PL202300156

BCS 5

SITE DEVELOPMENT PLANS
FOR
BCS PHASE 5

No.	Description	Date
1	Pre-Application DRC	9/6/2023

1 LOWER LEVEL FLOOR PLAN
A1.0 1/16" = 1'-0"

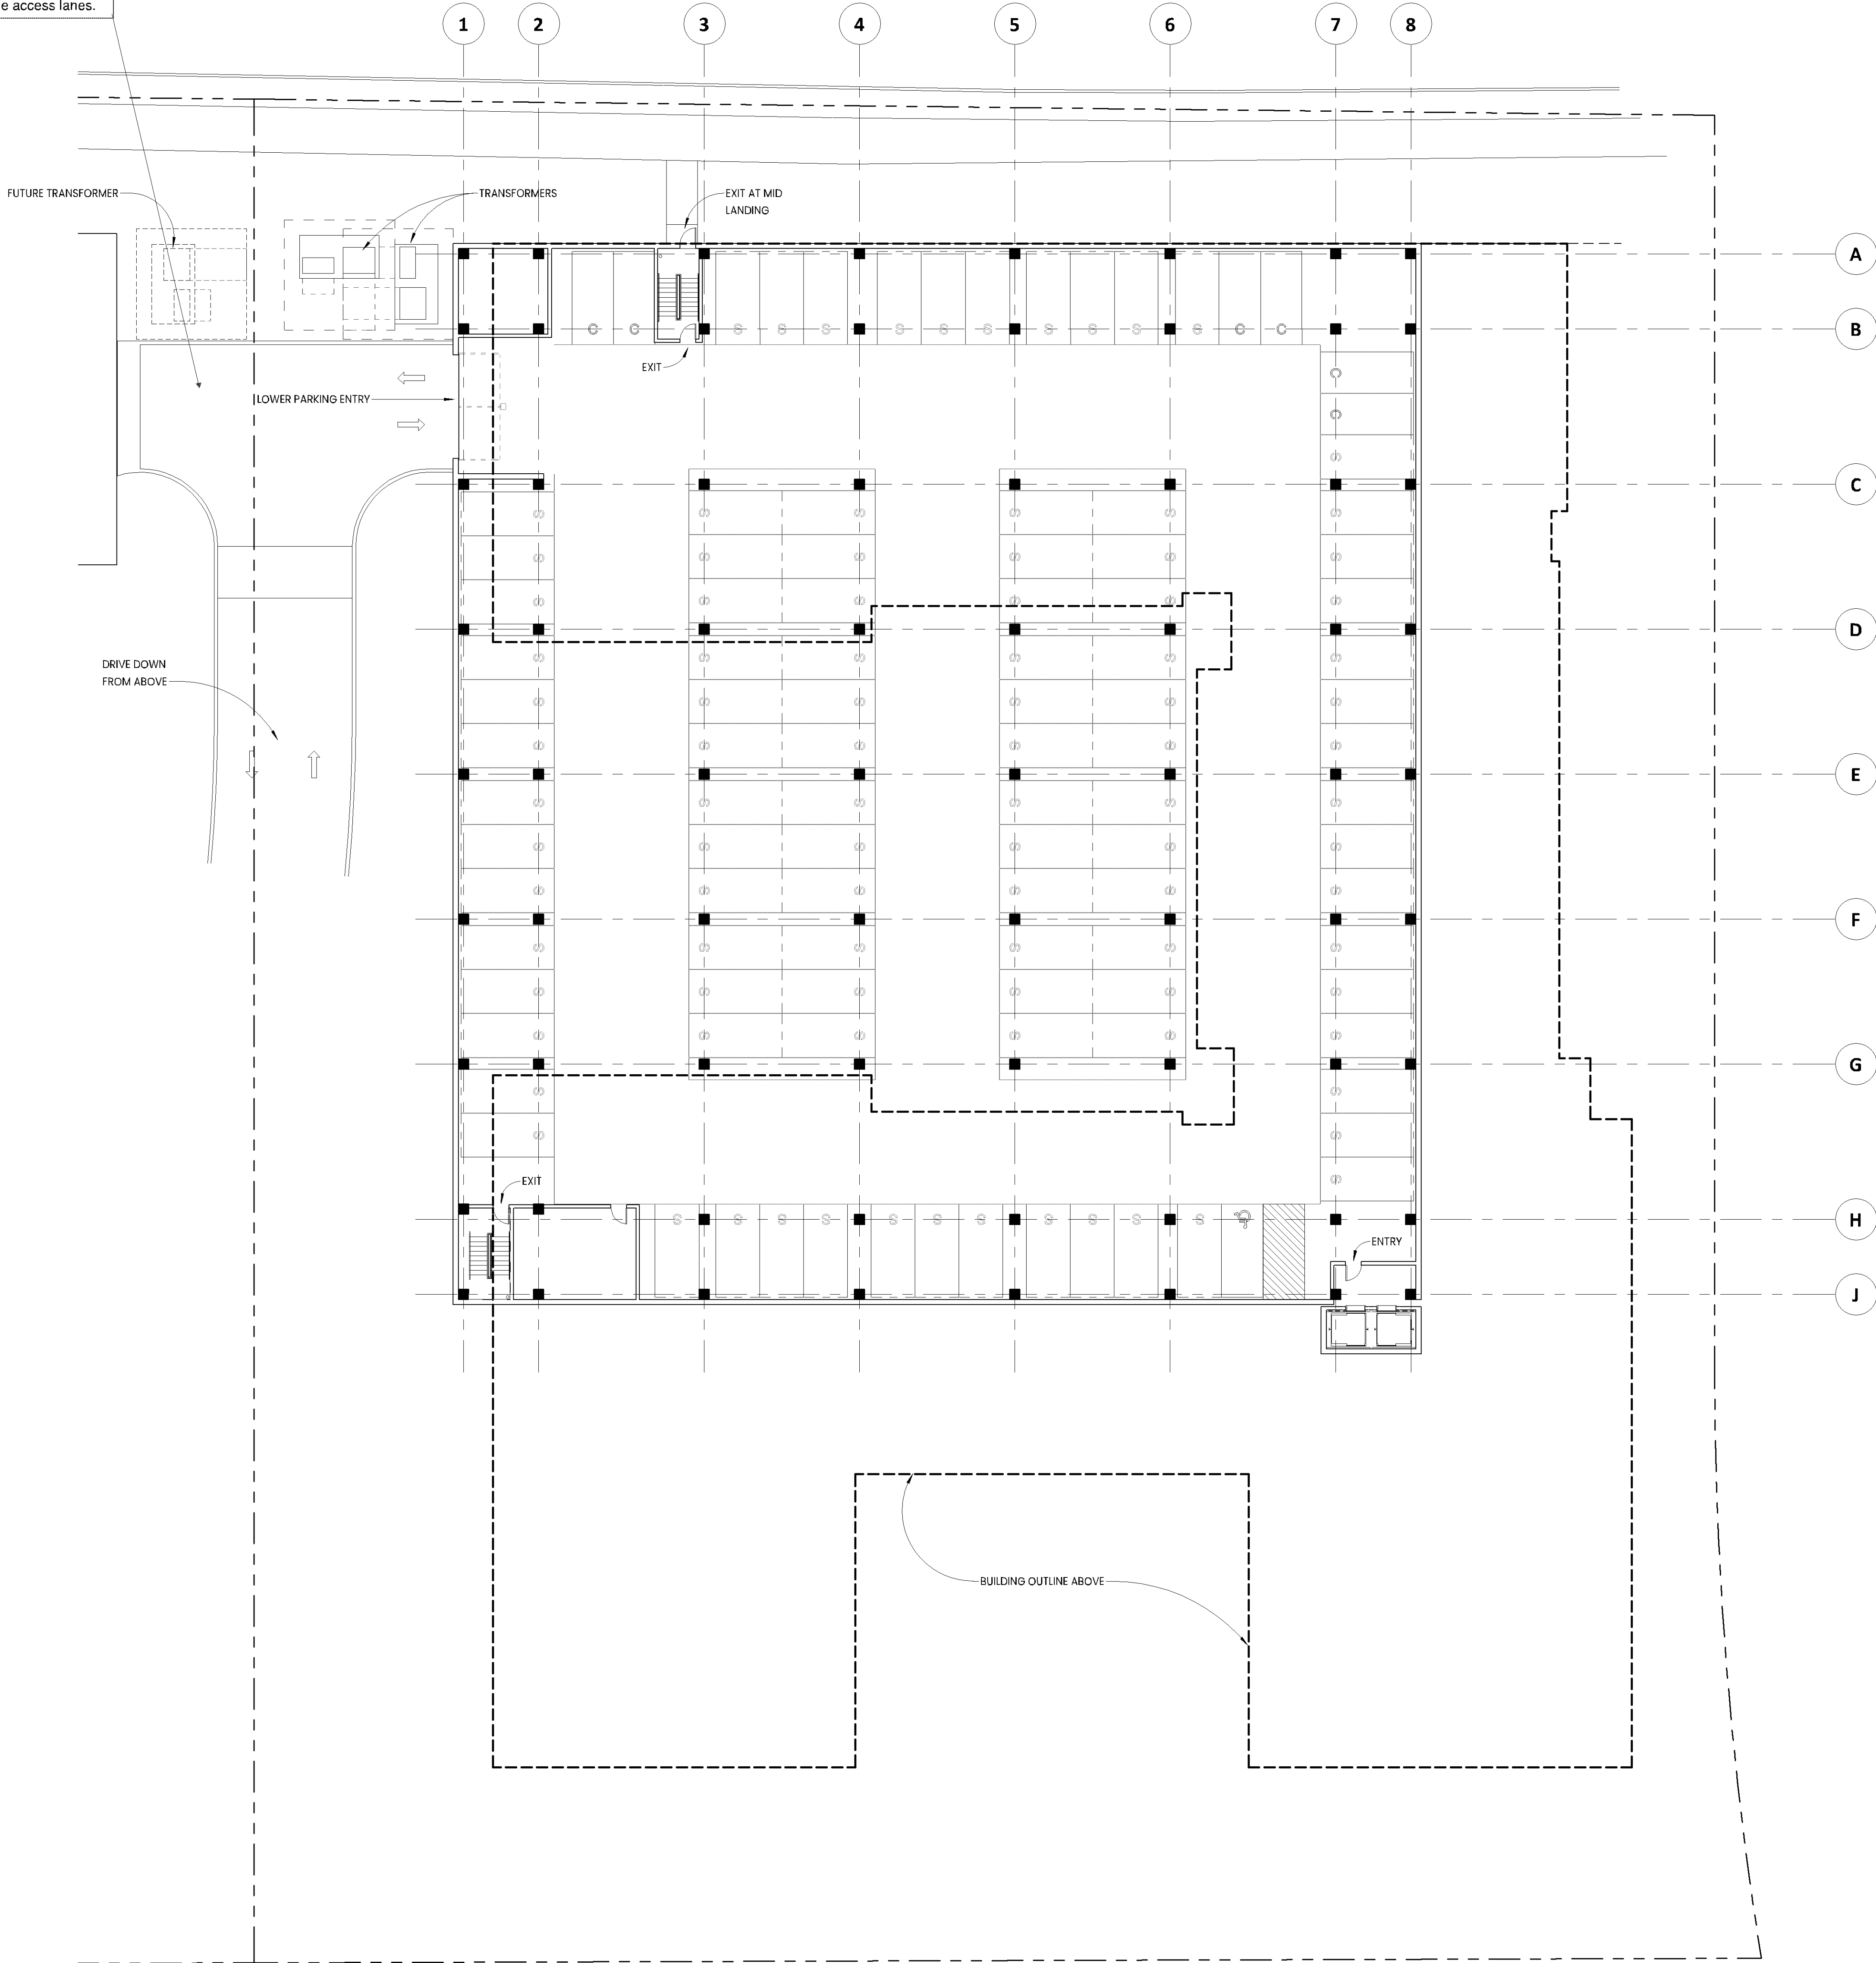
Must meet 2020 MN State Building Code

Building plans must be signed by a MN licensed architect.

SAC review by MET council will be required.

Must meet 2020 MN Accessibility Code.

Provide a detailed code analysis with the plans.

Separate permit and review by MN State Elevator inspector for elevators.

If there will be any alternate means requests - please schedule a meeting with City Plan Reviewer to discuss.

Hydrant coverage shall be provided within 50' of the FDC and within 150' of all portions of the structure.

Standpipes requirement in all stairwells and hose valves shall be located at the floor landing.

Emergency responder radio coverage shall meet appendix P of the MSFC and provided within structure.

Access shall be provided to/from all stairwells on all floors and parking levels.

Hose valves shall be provided throughout the lower level of the parking garage within 130' of all areas of the garage if dry standpipe or within 200 feet if installing a wet standpipe

All exterior doors that allow access to the interior of the building(s) shall be numbered in a sequential order starting with the main entrance (public entrance) as number 1 and continue in a clockwise manner.

Fire alarm panel(s), annunciator panel(s) and Knox box locations to be determined by the Fire Prevention Division.

Provide adequate turning radius for all emergency vehicle access lanes.
